# Access Compliance Report

## Public Rights-of-Way

### (Curb Ramps)

Intersection ID: 22027	Main Street: CAMBRIDGE CRESCENT DR	Cross Street: CARMEL CRESCENT DR	Location: S
ADA ID: B7DBFD407759	Ramp Type: PerpDiag	Initial Pass/Fail: Fail	Overall Compliance: No
		Severity Score: 12.5

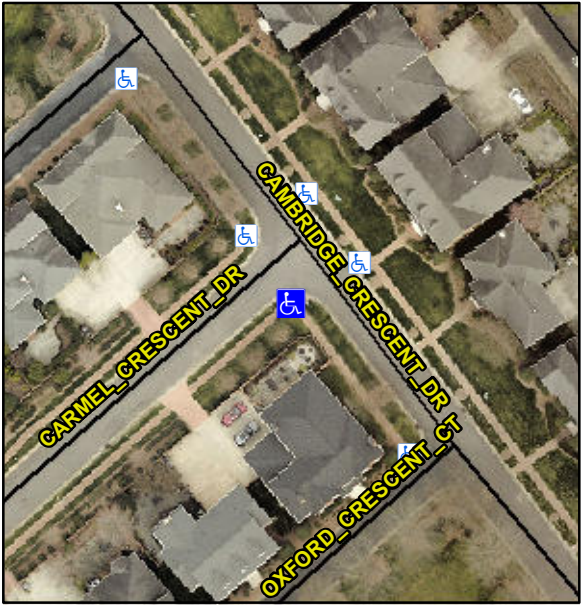
Codes/Mitigation Info/Possible Solution			Field Measurements/Component Compliance		
	Possible Solutions:		<b>Compliance</b>	<b>Description</b>	<b>Data</b>
	<b>Remove &amp; Replace Curb Ramp With Two New Directional Ramps or Equivalent.</b>		<b>Yes</b>	Ramp Length (in)	<b>68.0</b>
			<b>N/A</b>	Ramp Width (in)	<b>48.0</b>
			<b>N/A</b>	Flare Type LT	<b>N/A</b>
			<b>N/A</b>	Flare Slope LT (%)	<b>N/A</b>
			<b>N/A</b>	Flare Traversable LT?	<b>N/A</b>
			<b>N/A</b>	Landing Length (in)	<b>N/A</b>
			<b>N/A</b>	Landing Width (in)	<b>N/A</b>
			<b>N/A</b>	Landing Slope (%)	<b>N/A</b>
			<b>N/A</b>	Landing X Slope (%)	<b>N/A</b>
<p>Surveyor Notes:</p> <p><b>N/A</b></p> <p>PROW/ADA:</p> <p><b>R304.5.3</b></p>			<b>N/A</b>	Flare Type RT	<b>N/A</b>
			<b>N/A</b>	Flare Slope RT (%)	<b>N/A</b>
			<b>N/A</b>	Flare Traversable RT?	<b>N/A</b>
			<b>N/A</b>	DWS Provided?	<b>N/A</b>
			<b>N/A</b>	DWS Contrast?	<b>N/A</b>

<b>N/A</b>	DWS Length (in)	<b>N/A</b>
			<b>N/A</b>	DWS Full Width?	<b>N/A</b>
			<b>N/A</b>	DWS Offset (in)	<b>N/A</b>
			<b>N/A</b>	Gutter Ponding?	<b>N/A</b>
			<b>N/A</b>	Gutter Lip Ht (in)	<b>N/A</b>
			<b>N/A</b>	Painted X Walk1?	<b>No</b>
				X Walk 1 Direction	<b>To NE</b>
			<b>N/A</b>	X Walk 1 Width (in)	<b>N/A</b>
				X Walk 1 Slope (%)	<b>0.5</b>
				X Walk 1 X Slope (%)	<b>3.7</b>
			<b>N/A</b>	Ramp inside XWalk1?	<b>N/A</b>
				Road Slope (%)	<b>4.2</b>
				Road X Slope (%)	<b>2.6</b>
			<b>N/A</b>	Any Obstructions?	<b>N/A</b>
				Obstruction Type	
Total Cost: \$ 3200.00			<b>N/A</b>	Storm Grate/Utility Hazard?	<b>N/A</b>
				Storm Grate/Utility Type	
			<b>N/A</b>		<b>N/A</b>
			<b>Yes</b>	Surface Condition? (G/P)	<b>Good</b>
